Re: Gila River Indian Community Comments on the Draft Class III
Underground Injection Control Area Permit for the Proposed Florence Copper
Project, Florence Copper Project Production Testing Facility, Florence, Pinal
County, Arizona

COMMENTS OF THE GILA RIVER INDIAN COMMUNITY ON THE DRAFT CLASS III UNDERGROUND INJECTION CONTROL AREA PERMIT FOR THE PROPOSED FLORENCE COPPER PROJECT PRODUCTION TESTING FACILITY

Subject: Florence Copper Project – Technical Aspects of the EPA Underground Injection Control Well Permit

Figure 6 - One Year On, One Year Off - Uniform Hydraulic Conductivity - Particle Tracks

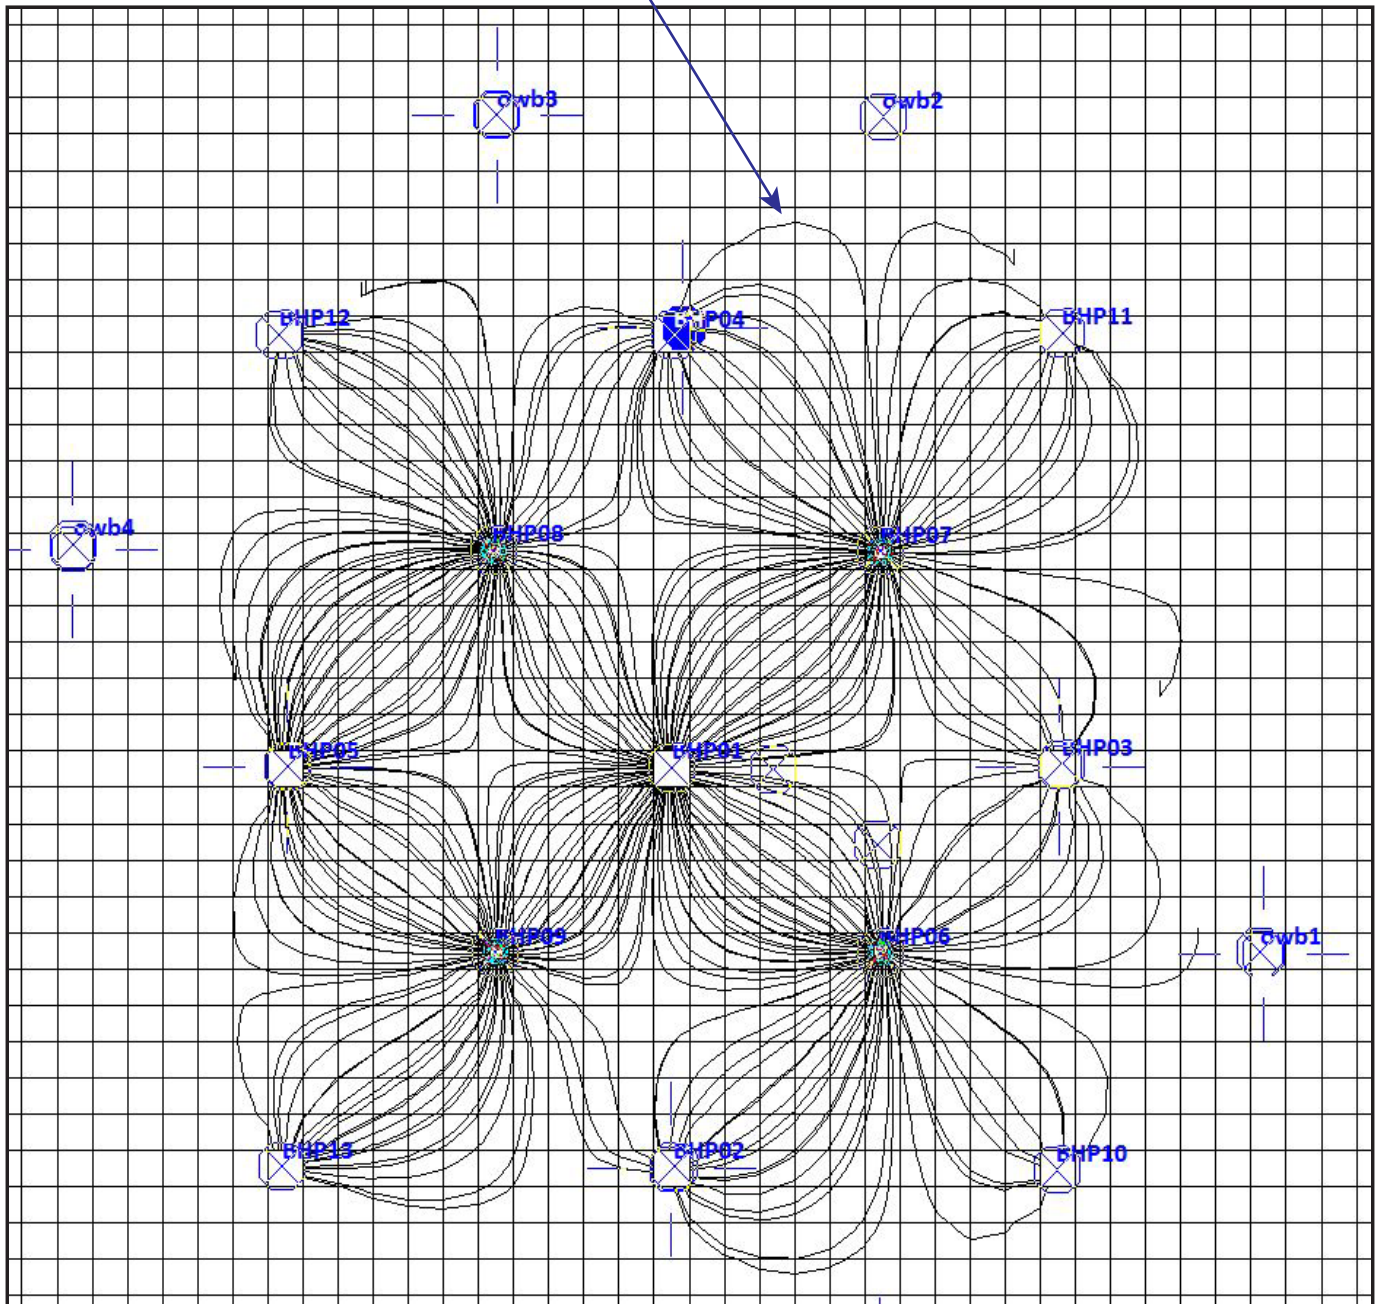
Two additional simulations were prepared to observe the effects of individual pumping rates. The rates during the official 90-day Pilot Test were extended for a year and then turned off. As extraction is continued, the particles were drawn around and back into the extraction wells. It appears that the observed spikes of low pH and elevated sulfate at some observation wells noted in the data by the Appellants could be explained by travel along the particle tracks similar to those simulated here for the test. There was more than a one foot inward water level difference between the locations of the extraction wells and the observation wells just outside when this escape was occurring. See Figure 6 for the simulated particle tracks resulting from the case of using a uniform K and extending the 90-Day BHP test rates for a year and then turning them off. The water particles not yet drawn into an extraction well when the system is turned off will eventually head away from the test wells with the background groundwater flow.

**Figure 7 - One Year On, One Year Off - Uniform Hydraulic Conductivity - Particle Tracks
Move Half of Extraction on Downgradient Side to Upgradient Side**

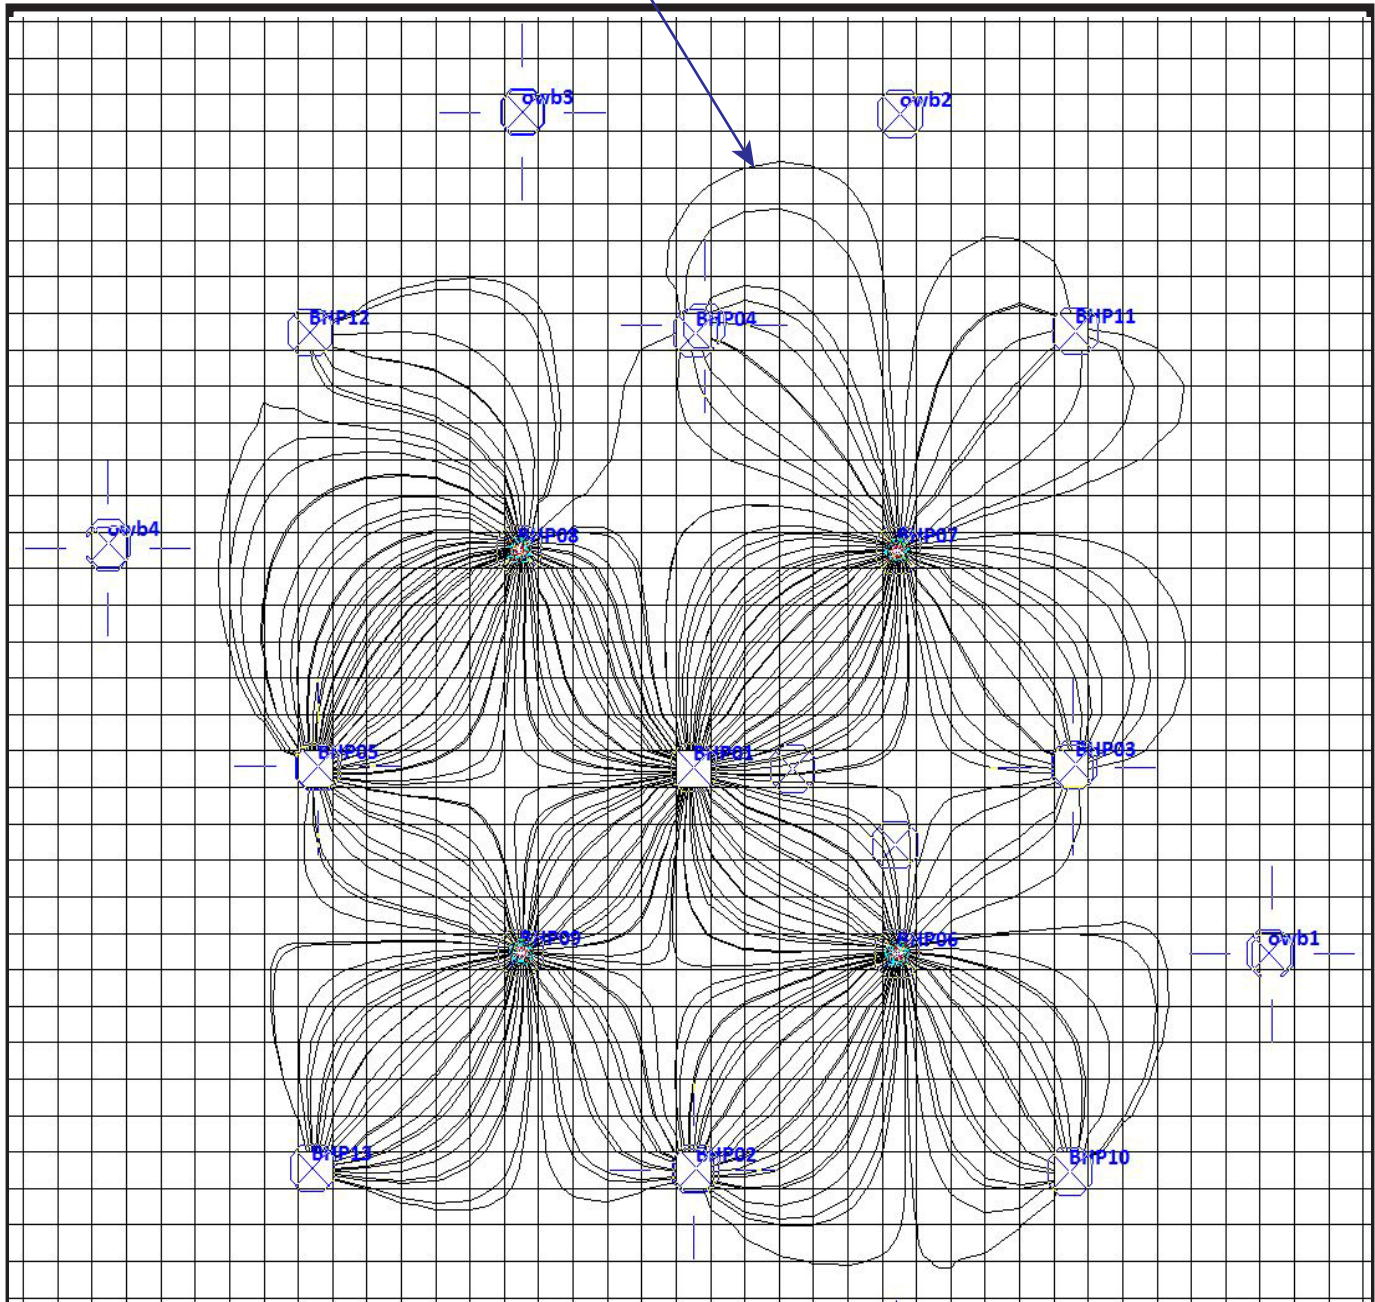
When the pumping rates for the three downgradient wells were decreased by half and these rates were added to the three upgradient extraction wells, the potential for drawing water back into extraction wells was more evident in that particles proceeded farther down gradient between the extraction wells, but were eventually drawn back in. Again, there was more than a one foot water level difference between the locations of the extraction wells and the adjacent observation wells. See Figure 7 for the simulated particle tracks resulting from the case similar to that of Figure 6, but with half of the pumping at the downgradient extraction wells transferred to the upgradient extraction wells.
